Rè: Indian Point 3

Docket No. 50-286

The hardware inside containment for the Overpressurization Protection System (OPS) was installed in Indian Point 3 during the current turbine maintenance outage which began in early October. Details of the design of this system as well as a generic pressure transient analysis were forwarded to you in letters dated February 28, April 5, August 9 and September 20, 1977.

Figure 1

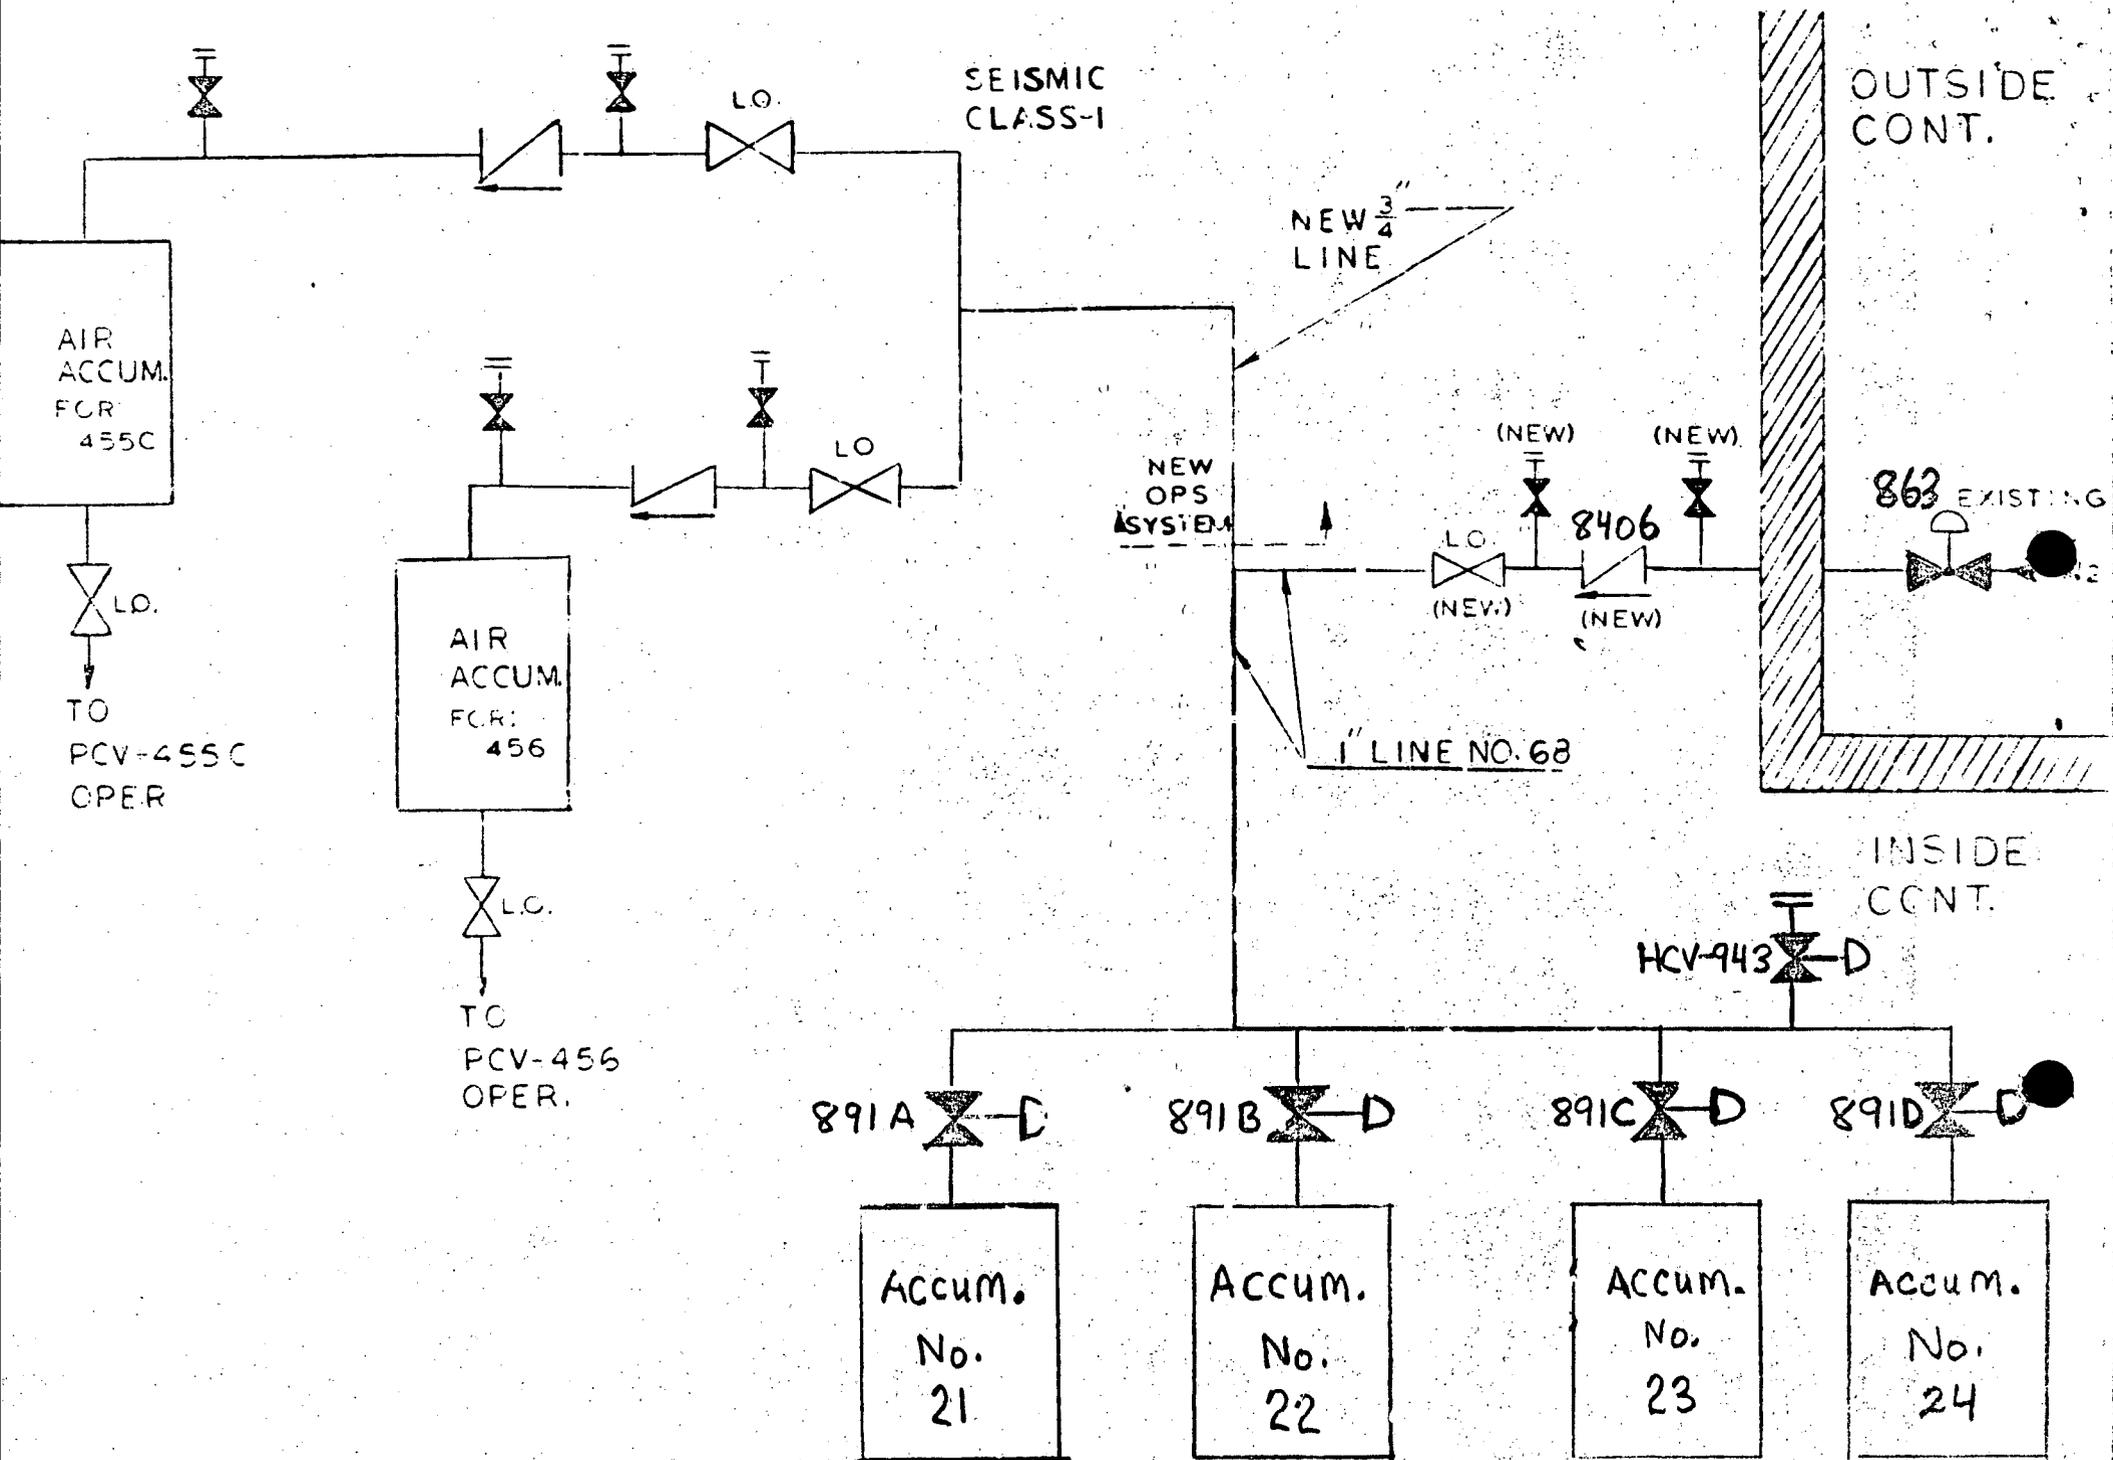
As part of the new Overpressurization Protection System, check valve 8406 was installed in series with existing valve 863 (see attached Figure 1). Check valve 8406 has been leak tested and qualified in accordance with Appendix J requirements. This check valve will also satisfy the containment isolation requirements presently satisfied by valves 891 A, B, C and D for the N<sub>2</sub> supply to the ECCS accumulators.

As a result of the addition of the Overpressurization Protection System, proposed changes to Tables 3.6-1 and 4.4-1 of

the Appendix A Technical Specifications will be submitted as part of the next license amendment application to include check valve 8406 and to delete valves 891 A,B,C and D.
